U.S. Department of the Interior BUREAU OF LAND MANAGEMENT Sundry Print Report

Well Name: BIG STAGG FED COM Well Location: T21S / R32E / SEC 1 / County or Parish/State: LEA /

Notice of Intent

Procedure Description: Ascent Energy respectfully requests approval on the Big Stagg Fed Com 503H for an option to: • Addition of an External Casing Packer on the 9-5/8" Casing • Increase the casing size of our vertical casing strings • Revise proposed BOP beneath the base of the 20" surface shoe to setting the 1st Intermediate casing string only (13 3/8"). The reason for the request is based on improved drilling efficiencies and improved cementing in-place for each casing string. We believe the larger casing diameters in the vertical section will increase the likelihood of getting cement to surface for each string. Please see the attached document for further information.

ASCENT ENERGY 2M ANNULAR BOPE & DIAGRAM

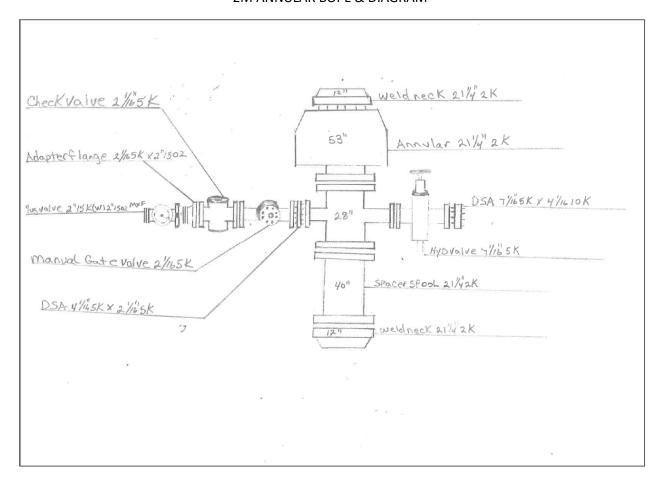
New Proposed BOP:

From the Base of the 20" Surface pipe, the well will be equipped with a 2M Annular system. Before drilling out the 20" surface pipe, the 2M system will be tested to 250psi low and 1000psi high by an 3rd party service company. The 2M BOPE and related equipment will meet or exceed the requirements of a 2M psi system as set forth in On Shore Order No. 2 while drilling below the 20" surface shoe and to TD of Intermediate #1 (13-3/8" Casing). Once the Intermediate #1 13-3/8" Casing is cemented the 20" 2M BOPE and 21-1/4" wellhead will be removed and a 13-5/8" Multi-bowl wellhead and previously permitted 13-5/8" 5M BOPE will be installed. From the base of the Intermediate #1 13-3/8" casing string through running of the 5-1/2" production string the 5M BOPE will be equipped.

The previously permitted 5M choke will be utilized in conjunction with the 2M Annular System.

- 1. Variance approved to use flex line from BOP to choke manifold. Manufacturer's specification to be readily available. No external damage to flex line. Flex line to be installed as straight as possible (no hard bends).'
- 2. Operator has proposed a multi-bowl wellhead assembly. This assembly will only be tested when installed on the surface casing. Minimum working pressure of the blowout preventer (BOP) and related equipment (BOPE) required for drilling below the surface casing shoe shall be **2000 (2M)** psi.

- 3. Operator has proposed a multi-bowl wellhead assembly. This assembly will only be tested when installed on the surface casing. Minimum working pressure of the blowout preventer (BOP) and related equipment (BOPE) required for drilling below the intermediate 1 and 2 casing shoe shall be **5000** (**5M**) psi.
